ZONING BOARD OF APPEALS MEETING

LOCATION: TOWNSHIP ANNEX, 7527 HIGHLAND ROAD, WHITE LAKE, MICHIGAN, 48383
(FORMER WHITE LAKE LIBRARY)
THURSDAY, APRIL 28, 2022 – 7:00 PM

RE: Hypershine Auto Wash
Preliminary Site Plan and Special Land Use – Review #2

Staff reviewed the revised site plan prepared by Stonefield Engineering & Design (revision date March 16, 2022). The following comments from the first review dated February 18, 2022 are listed below. Responses to those comments are provided in **(red)**.

EAST ELEVATION
SCALE: 1/4" = 1'-0"

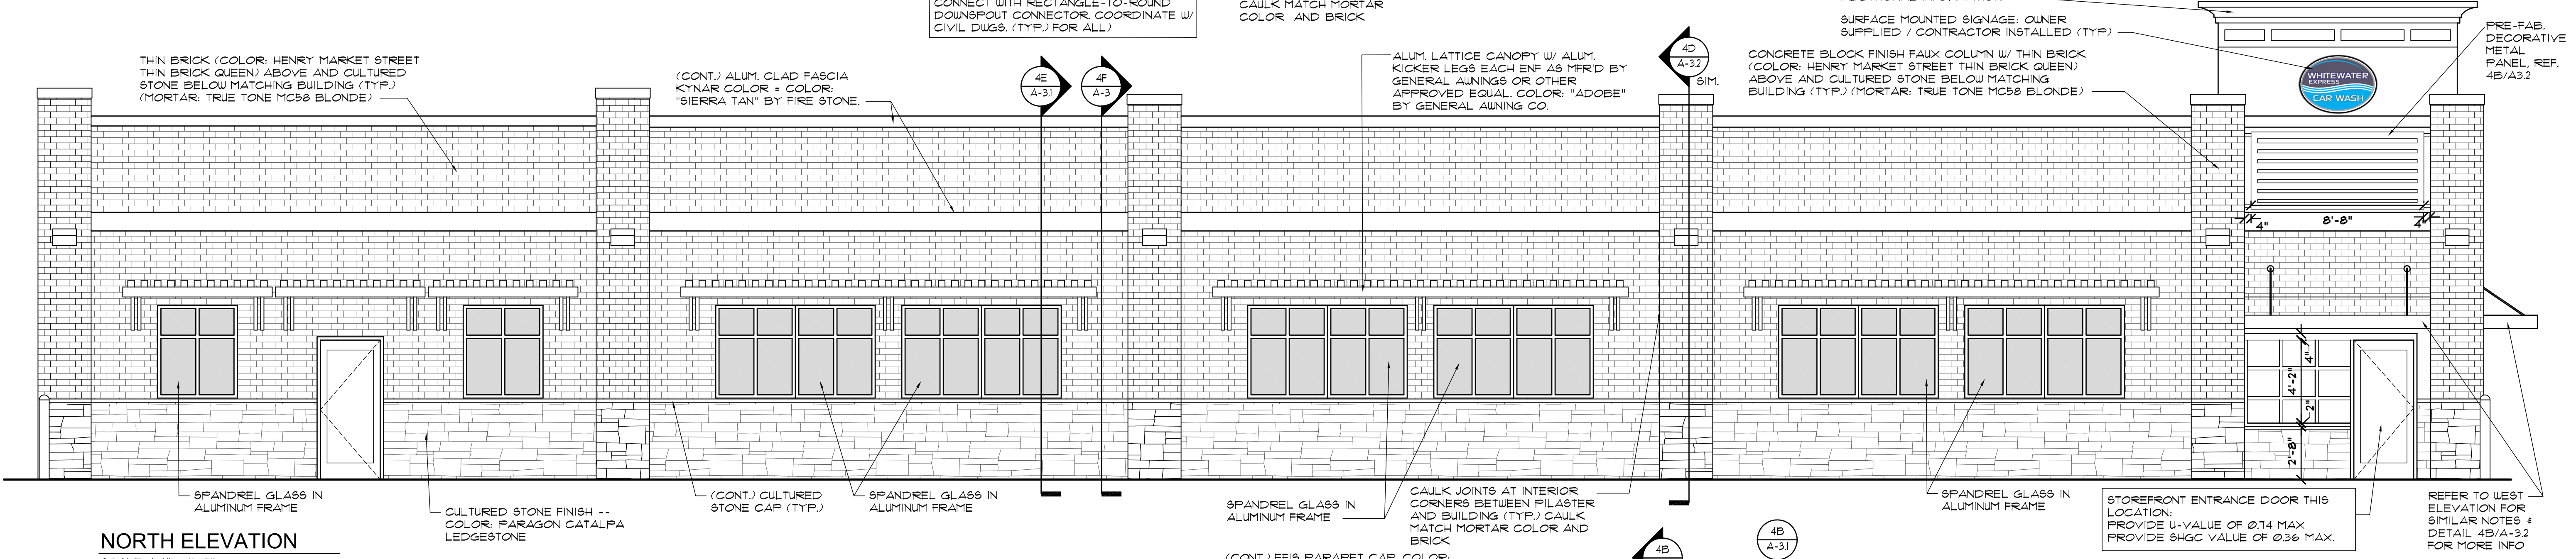
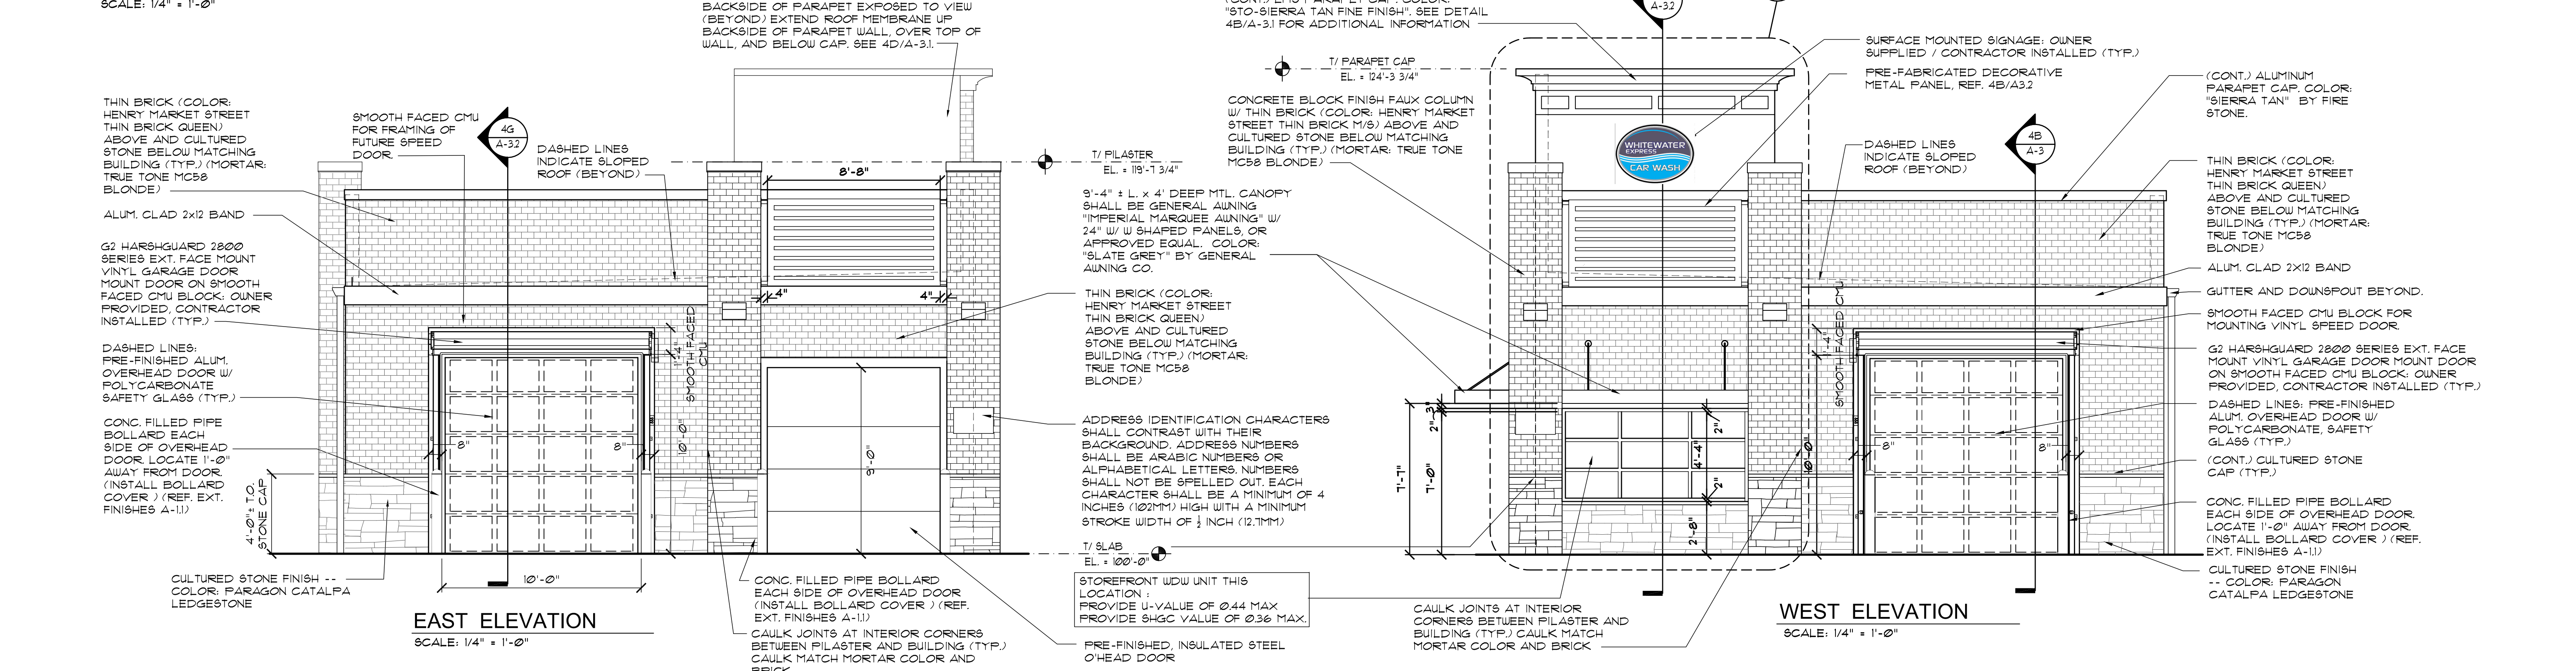
The applicant shall provide an explanation in writing for the purpose of the second overhead door (north door) on the east elevation of the building. (Comment partially addressed. The applicant's engineer stated the second overhead door at the exit is to be utilized for chemical deliveries and maintenance access to mechanical equipment. Sheet A-1 (floor plan) shows equipment locations. Sheet A-1 shall be revised; it incorrectly identifies the east elevation of the building as the car wash entrance and the west elevation of the building as the car wash exit. Those labels (and directorial arrows) are reversed and shall be revised at the time of final site plan).
